ADDENDUM NO. 1
to
PLANS and SPECIFICATIONS
for

Medina River Sewer Outfall, Segment 2
SAWS Job No. 11-2503

Issue Date: November 1, 2010

The purpose of this addendum is to issue revisions and clarifications for the Medina River Sewer Outfall, Segment 2 (SAWS Job No. 11-2503).

SHEET INDEX, BID QUANTITIES AND LEGEND

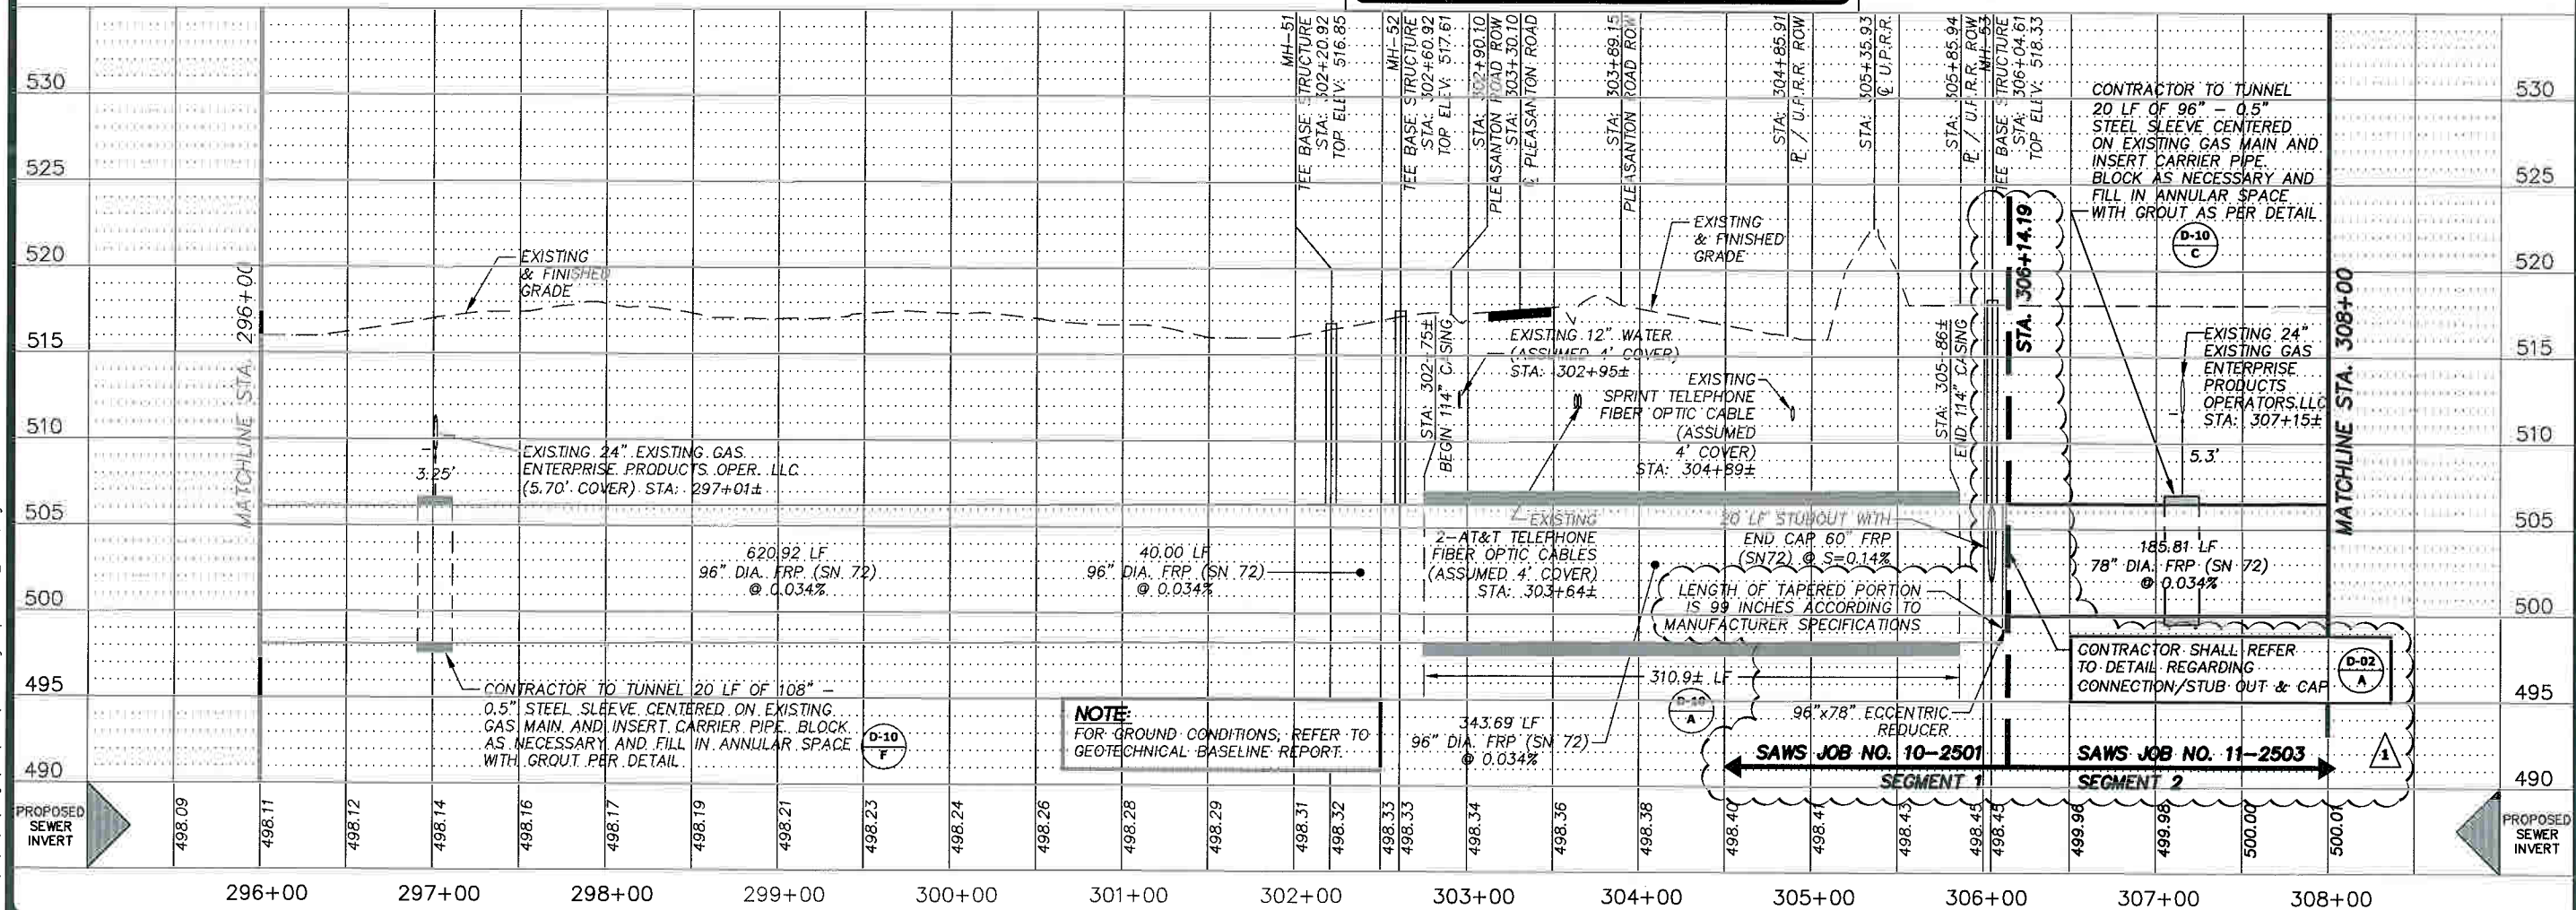
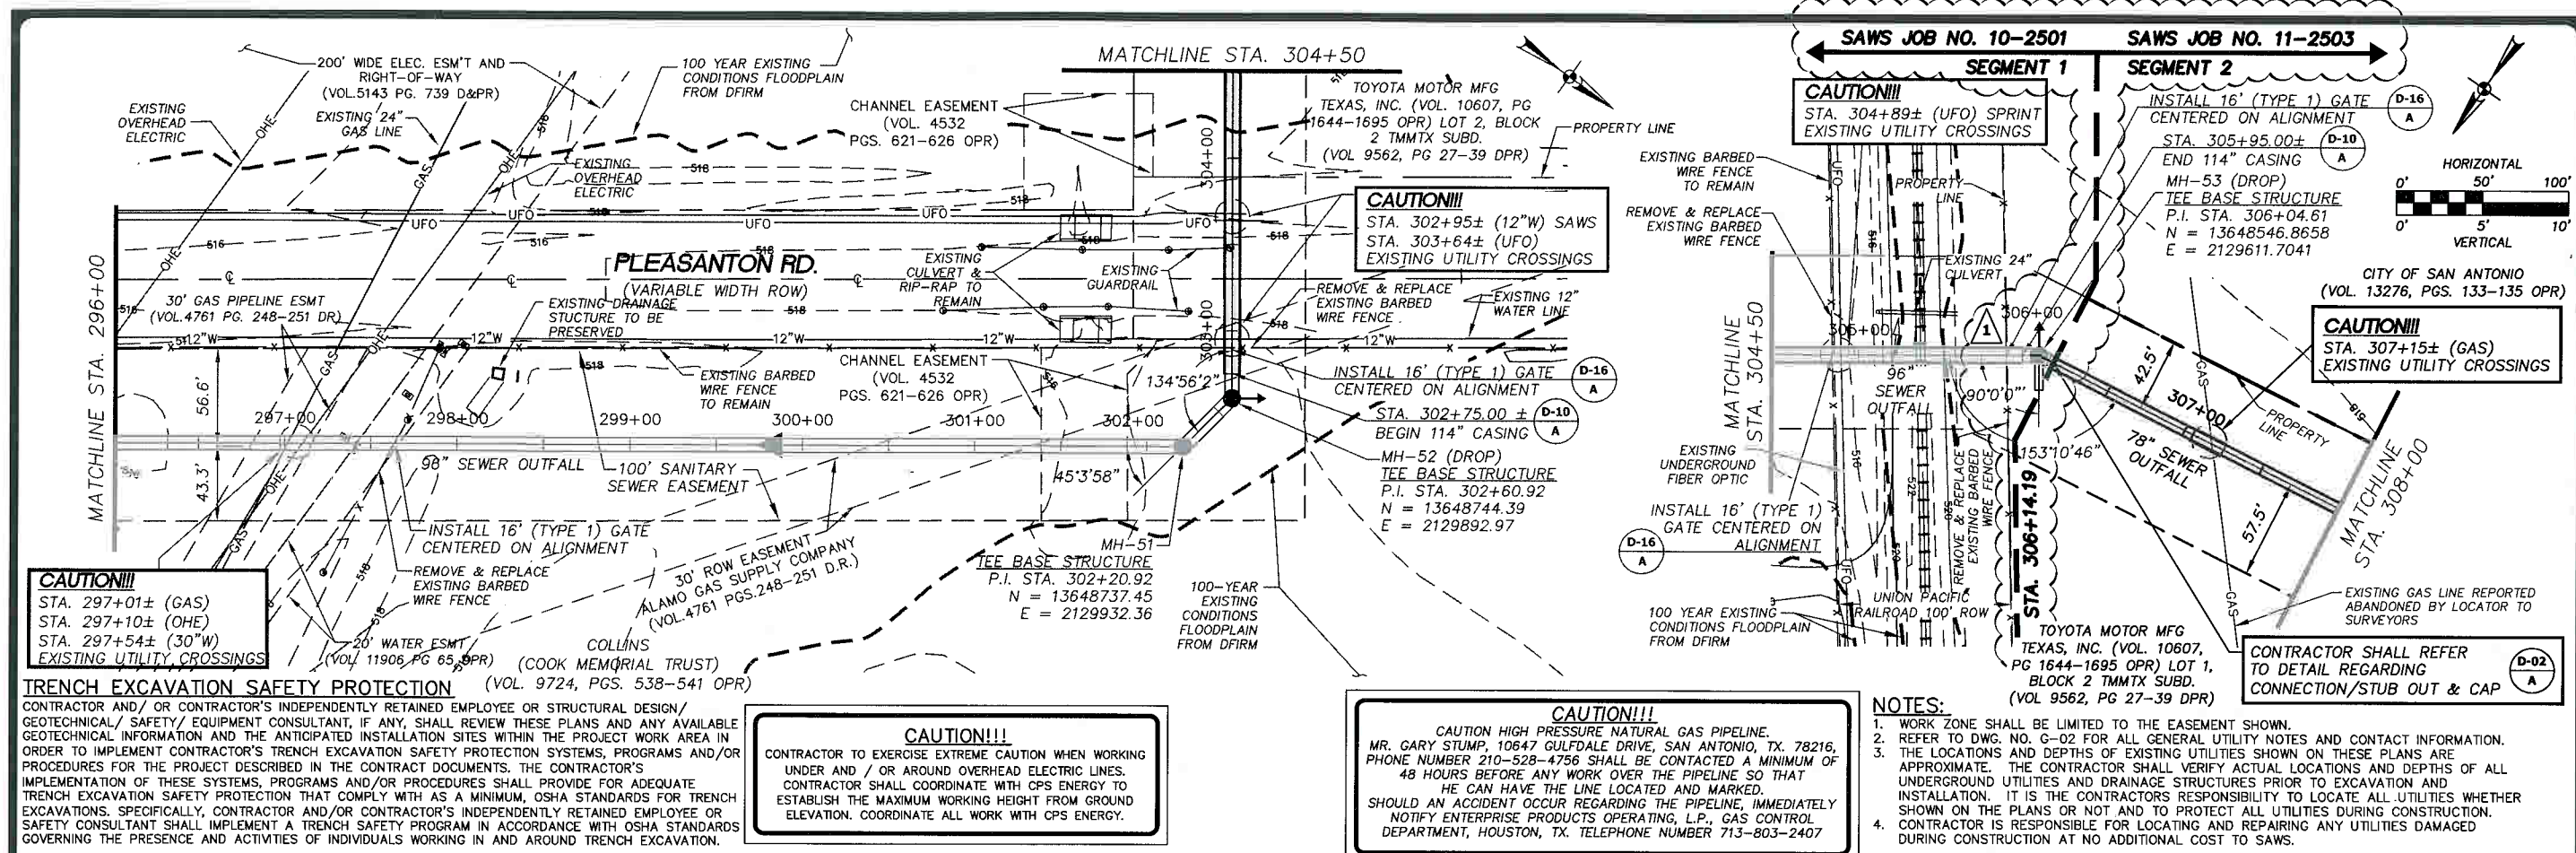
- A. Drawing No. G-01, Sheet No. 2 – The Bid Quantities have been revised. Remove and Replace this sheet with the attached plan sheet.
- B. Drawing No. C-25, Sheet No. 12 – The beginning station and associated dimensions have been revised. Remove and replace this sheet with the attached plan sheet.

**PLAN & PROFILE SHEET
 STA. 358+00 TO STA. 370+00**

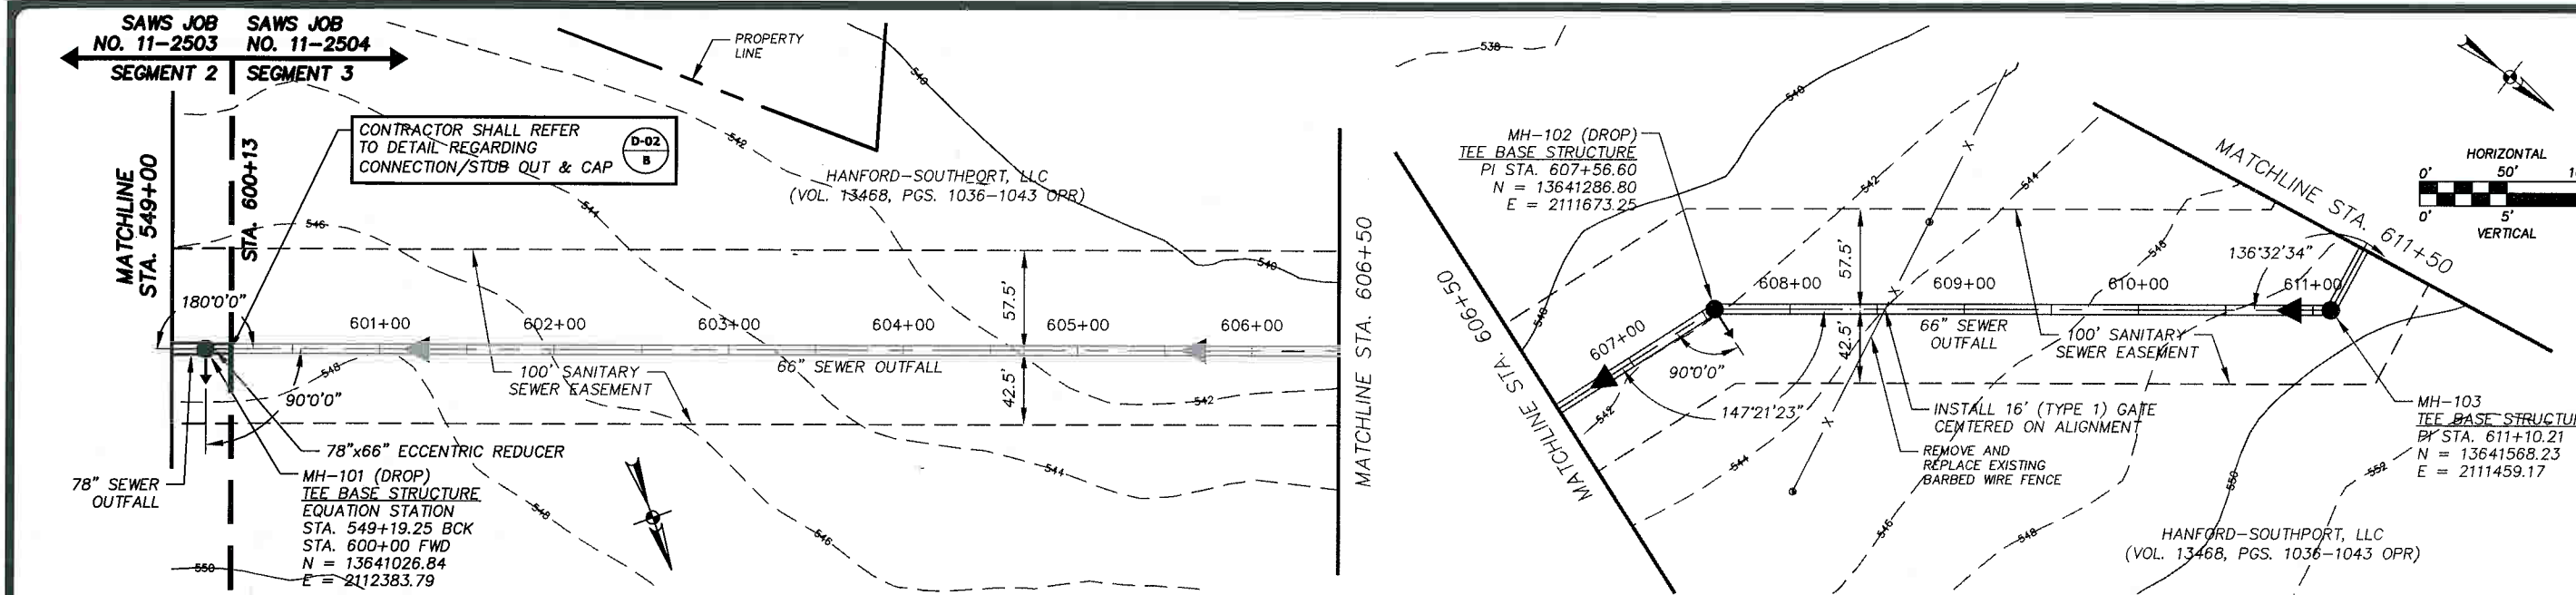
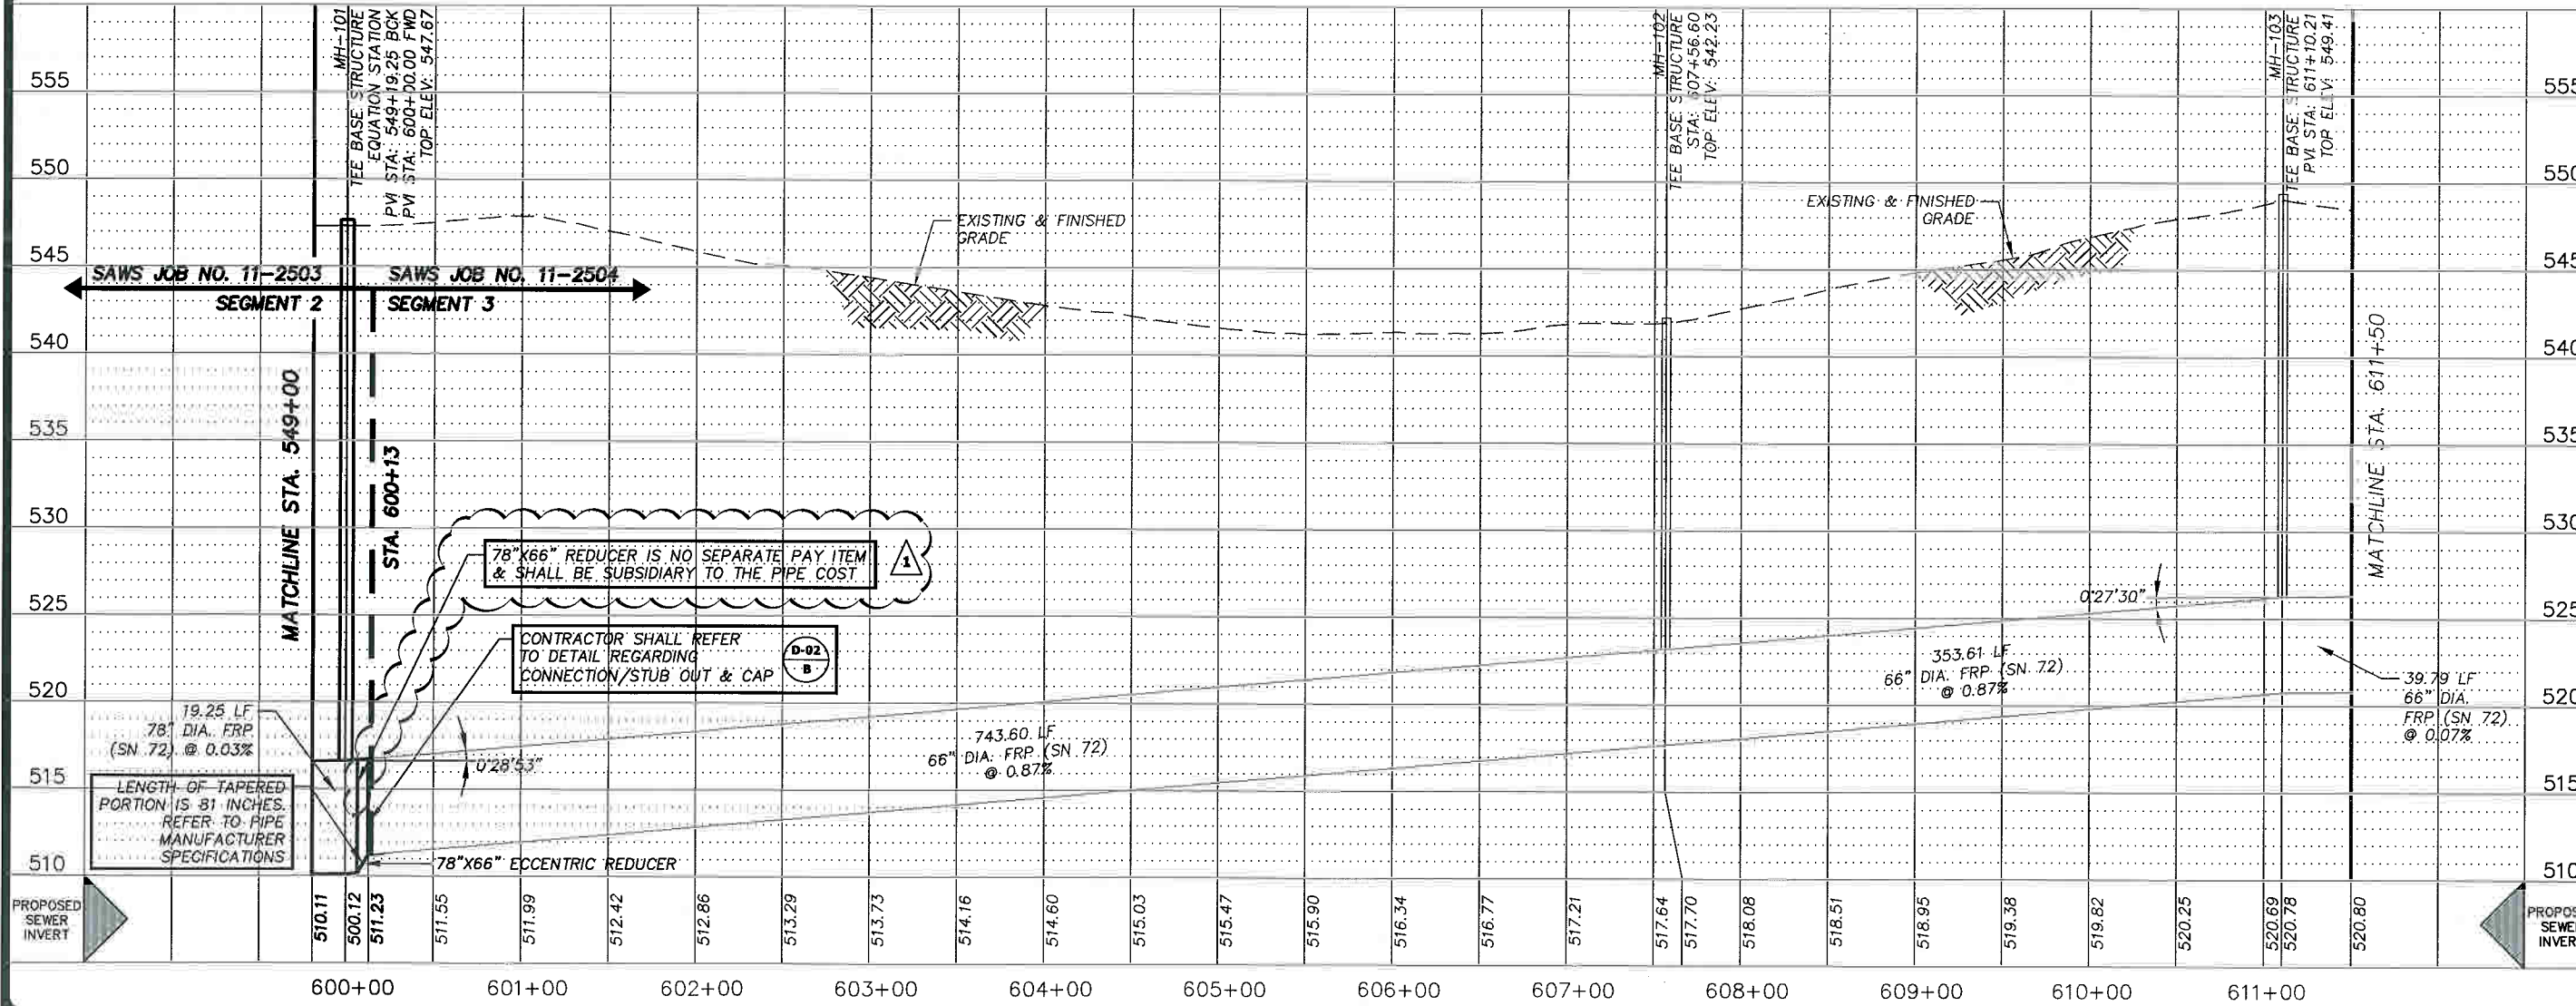
- D. Drawing No. C-28, Sheet No. 15 – The Erosion Control Matting shown on the profile shall be a no separate pay item and is subsidiary to Bid Item # 1. The 12”, 36”, and 42” Siphon Barrels shall be FRP SN72 and shall meet the requirements of Project Specification SS848. Remove and replace this sheet with the attached plan sheet.

**PLAN AND PROFILE SHEET
 STA. 549+00 TO STA. 600+13**

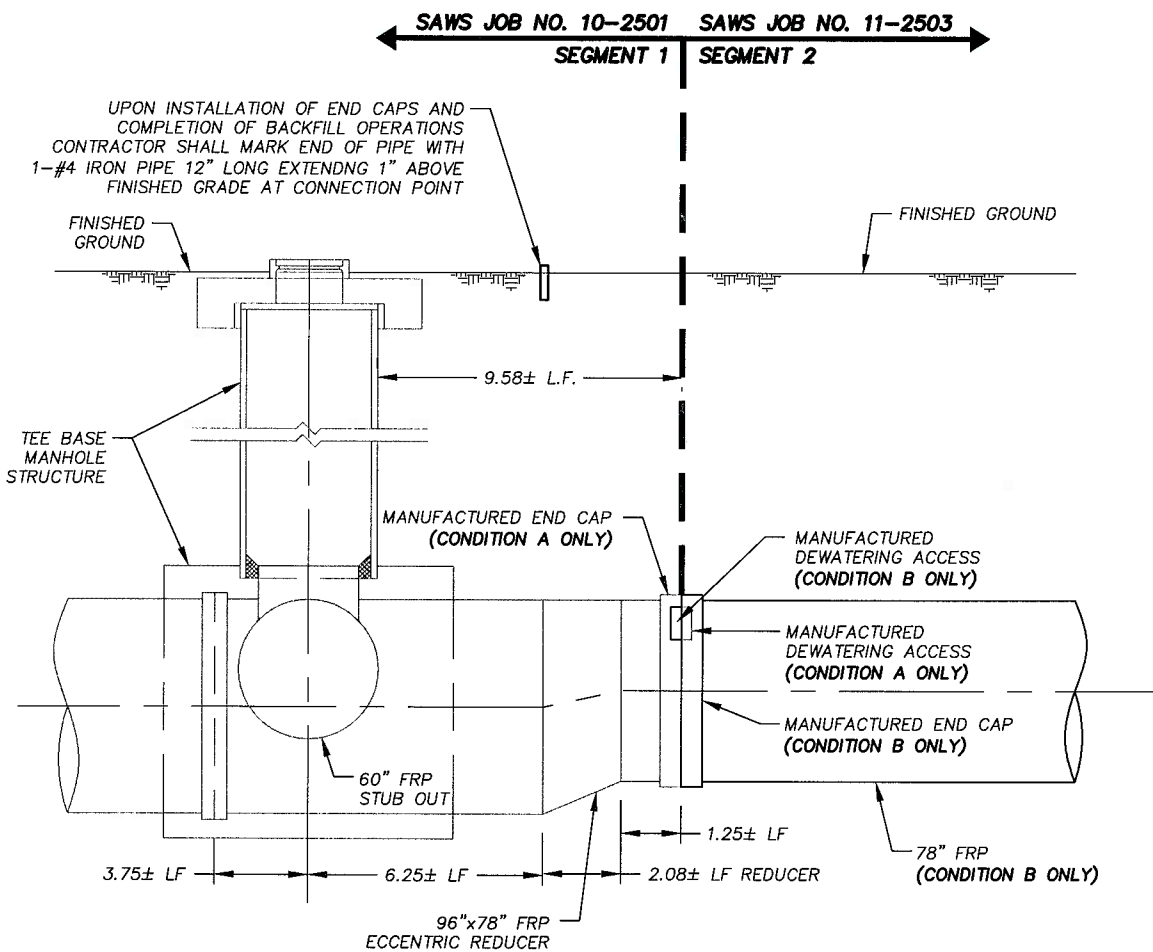
- E. Drawing No. C-44, Sheet No. 31 – The 78” X 66” reducer is a no separate pay item and is subsidiary to Bid Item # 4. Remove and replace this sheet with the attached plan sheet.
